RE: Bloomfield Refining Company
#50 County Road 4990
Bloomfield, New Mexico
EPA ID No. NM089416416
Administrative Order on Consent - Docket No. VI-303-H
Response to USEPA Comments on the Draft RFI/CMS Report

**RESPONSE TO USEPA COMMENTS ON THE 11/08/94 DRAFT RFI/CMS REPORT
BLOOMFIELD REFINING COMPANY**

BLOOMFIELD REFINING COMPANY, NEW MEXICO
WELL RW-22 WATER LEVEL RECOVERY
JUNE 9 AND 10, 1994

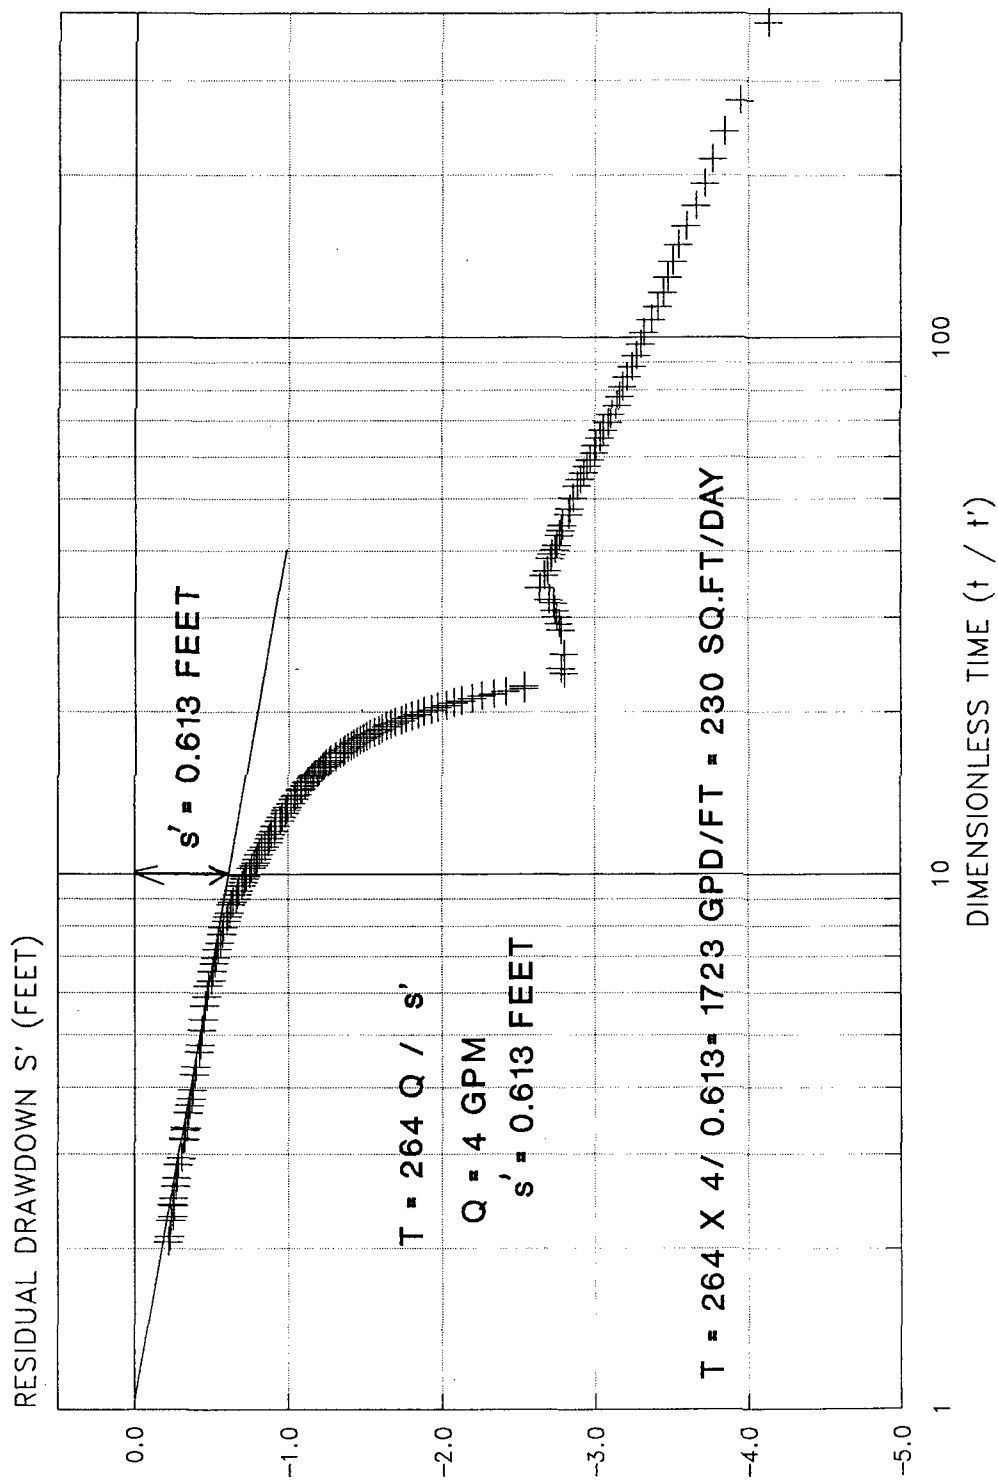
Appendix G of the UAHTM report generally describes how Jacob's method of analysis was utilized for the determination of aquifer characteristics. Appendix G did not include detailed calculations regarding this analysis method and therefore, EPA cannot determine if this method was correctly applied. BRC shall include detailed calculations to illustrate how the aquifer parameters were determined. These calculations shall include a description of the data points that should not be included (i.e. due to the error for small time in the logarithmic approximation) in the determination of the straight line within the method.

Response: Detailed calculations are included on each plot (Appendix G), showing the time-recovery data collected in observation wells MP-3 and MP-4 (Appendix E), and in test well RW-22 (Appendix F). The slope of the water level recovery straight line(s), calculated from an observation well per one log-cycle, is used to solve the transmissivity equation using the well discharge rate. If observation wells are not present or if drawdown in the observation wells are insignificant, data from the pumping well can be used for the calculation of aquifer's transmissivity. Storage coefficient (S) cannot be calculated from the pumping well data.

The second revision of water level recovery data of well RW-22 indicated that the slope of the straight line is 0.6 feet rather than 0.4 feet. This has resulted in a transmissivity value of 1,723 gpd/ft (230 Ft²/day).
